File FPP-1996-201

Name: Cottages at Wellington - #2 - SE Corner 15th Street / Wellington Avenue

ACTION REQUESTED: Approval of the Cottages at Wellington Filing 2 Final Plat and Plan

SITE PLAN
 Located in Section 12, T1S, R1W, Ute PM
 Grand Junction, Mesa County, Colorado

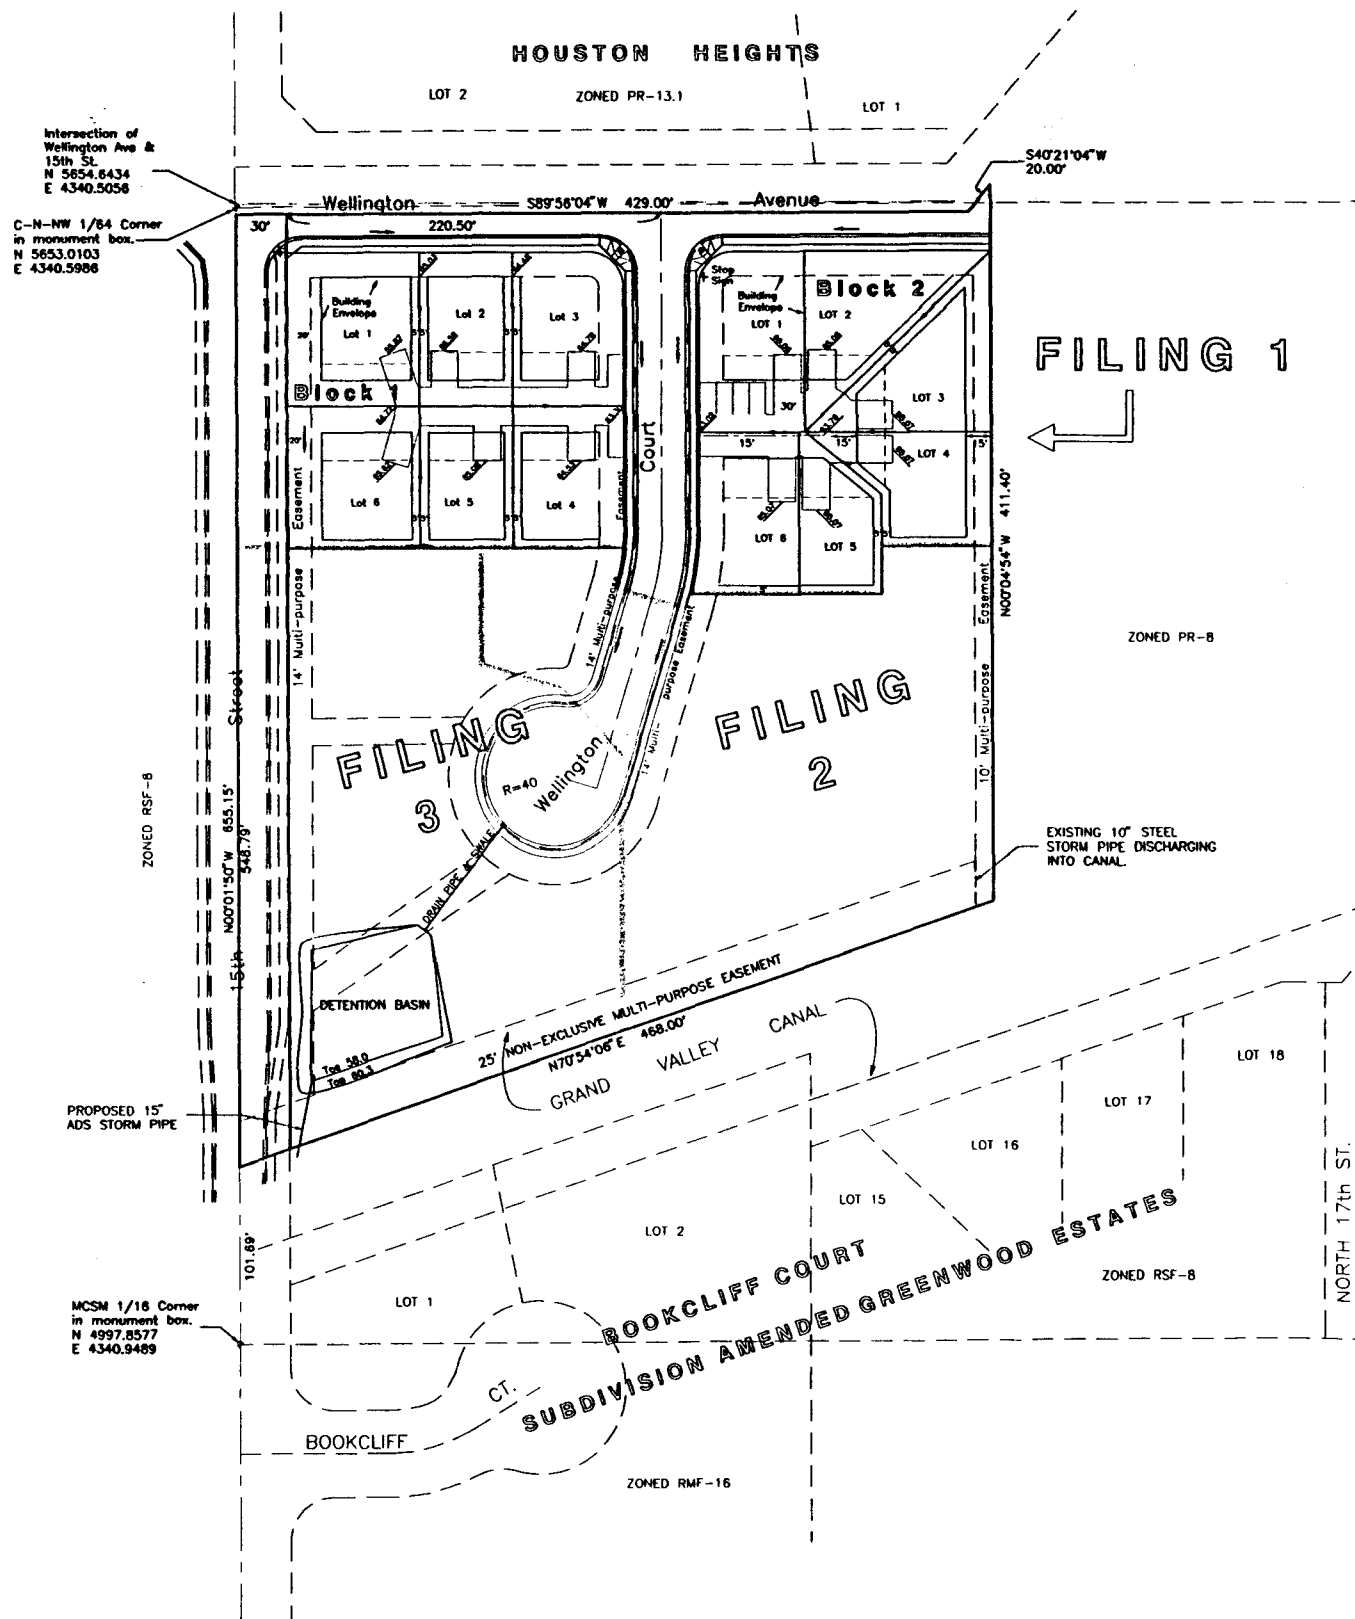
SITE PLAN

1. Include a table of setbacks as on the Final Plat.
2. Revise Note 5 to clarify: Driveways shall be no less than 20 feet long at the shortest point measured from the property line at private drive or from public street.
3. Footprints shown on Lots 2, 3 and 13 clearly encroach in the setback. Need to revise.

4. Add a note regarding addition of decks, patios, etc. For guidance City/Building Dept. does not allow any encroachment into any setback. The Zoning and Development Code states: "Porches, Patios or decks which are open and uncovered may extend into any required SETBACK area not more than six feet but in no case closer than three feet to any property line." If something encroaches, it may never be covered/enclosed.

SITE PLAN

1. Filing 2 not shown.
2. Eliminate reference to Filing 2 and Filing 3.
3. Show and dimension all setbacks including garage setback. Make sure attached units show a 0-foot setback.
4. How will additions such as encroachment of patios/covered patios be handled?
5. Include a table of setbacks. Identify which lots have the 0-foot/common wall setback.
6. Further comments once a Site Plan is submitted.
7. Show any fencing that may be proposed, such as split rail fencing in Filing 1.

SITE PLAN

1. Need to show the 14-foot front yard setback for lots 8 thru 13 (setback from Tract A).
2. Lot 1 - dimension the setback from ingress-egress easement.
3. Lot 13 - footprint still appears to possibly encroach in the setback on the right side. Suggest 3-foot setback on this side instead of 5?
4. Setback Table - Clarify/correct the following on both Site Plan and Final Plat:

WELLINGTON GARDENS PHASE II
 1" = 20' N

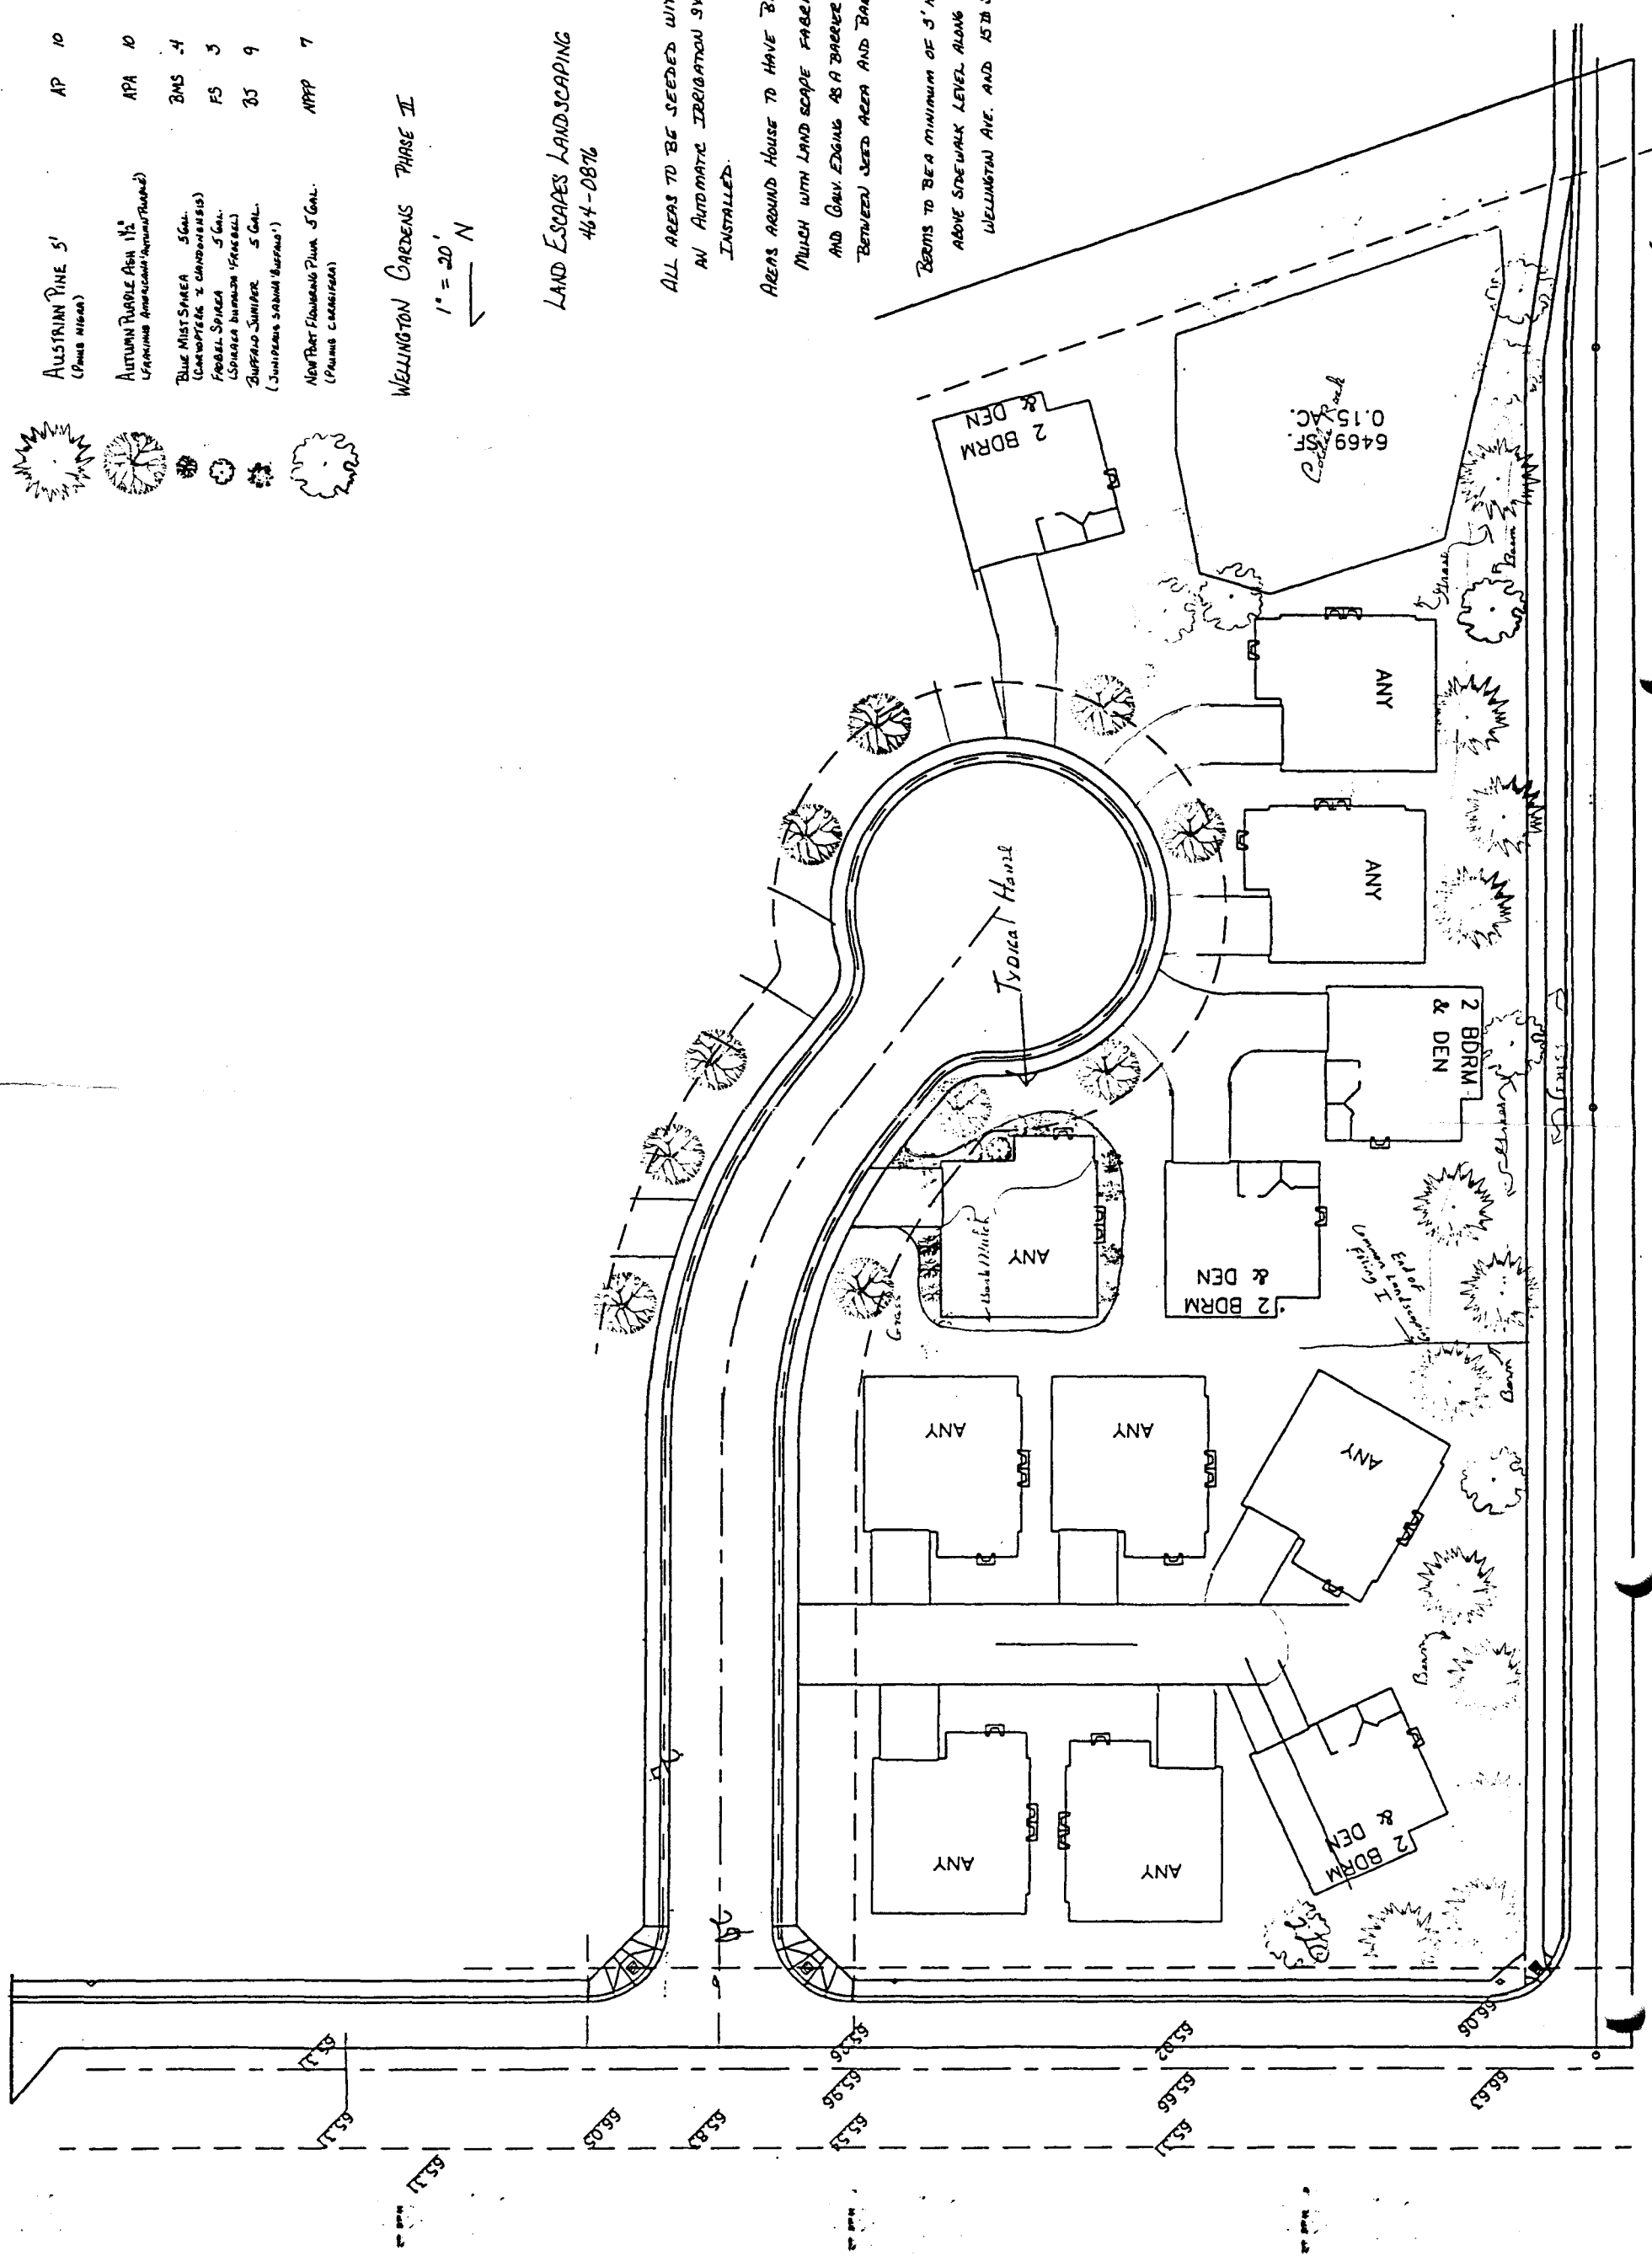
LANDSCAPE PLANS

1. Use correct site plan for landscape plans--there are no attached units proposed, yet landscape plan shows all attached units.

LANDSCAPE PLAN

1. Use the correct underlying plan and show lot lines.
2. Identify limits of existing/proposed landscaping.
3. Do the lump sums included in the Improvements Agreement and Guarantee include all of the landscaping shown on the plan including that in the pond (unless it is existing)? (see also comments from Development Engineer)
4. Berm within the easement along the canal is probably not acceptable to canal company. It would also be an impediment to a future trail along the canal.
